**State Significant Development (SSD 7692)
Response to Submissions
Multi-Agency Collocated Accommodation for Detector Dogs**

**Australian Border Force
Australian Federal Police
Department of Agriculture and Water Resources**

28A McPherson Street, Banksmeadow

3rd November 2016

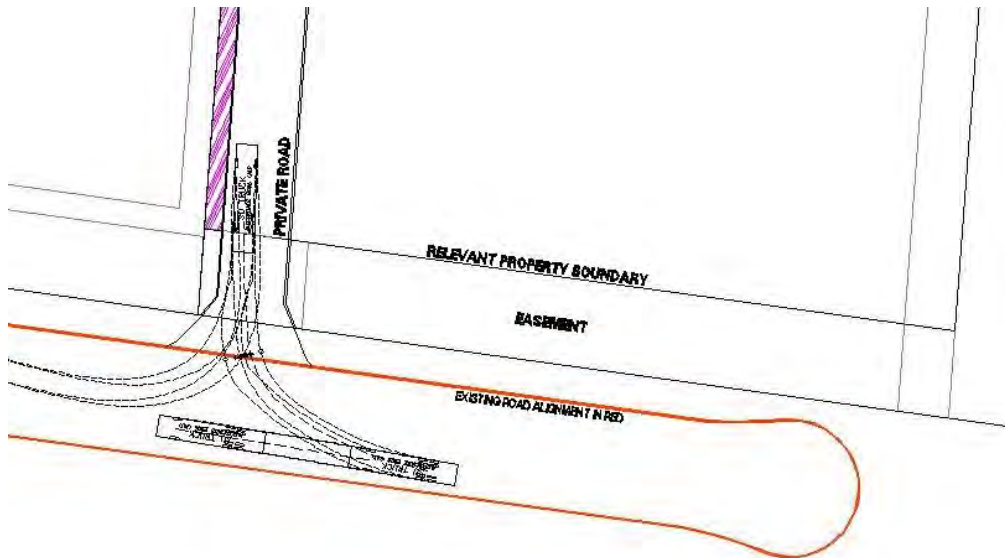
It has been requested by the adjoining land owner that a Flood Impact Validation Report be submitted at the completion of the facility. This is considered unnecessary as the previously prepared Flood Impact Validation Report (Hydraulic Modelling Flood Validation Assessment Review (Aurecon, May 2015) and supplementary assessment titled "Port Botany Industrial Estate Turning Head

Flood Impact Assessment” dated 28th August 2015 prepared by Aurecon has resolved that the eastern part of the Southlands site is not subject to flooding. As the subject site is not subject to flooding, the capping works which is currently being undertaken and the proposed construction of the Detector Dog facility will all occur above the flood level as generally shown on the below.

As the fill and buildings to be placed above it are situated above flood level, no increased flood impacts will be experienced by adjoining landowner due to displaced flood water. This has previously been covered by the original Orica Southlands Response to Submissions prepared by DBL property and issued to the Department of Planning and Infrastructure on the 18th June 2013. It was confirmed that:

"The area now proposed as Lots 7, 8 and 12 are generally shown in an area that is already above RL4.2 (which is the maximum 1 in 100 year flood level across the Southlands site) and not subject to 1:100 flooding currently. Accordingly the flood difference mapping will correctly show no change to afflux levels in this area."

Given that there is already a Flood Validation Report in place which acknowledges that the subject site is above the flood level, the placement of buildings on the site will not take away flood storage and therefore not impact adjoining properties. It is considered appropriate that an as-built feature level survey be submitted demonstrating that the site levels have not been reduced to below the flood level.

The following condition is suggested as an alternative to Hynlong Pty Ltd suggested condition:

"Upon completion of all works and prior to the occupation of the facility, a feature level survey must be submitted demonstrating that the finished site levels are no lower than the RL 4.2 flood level."
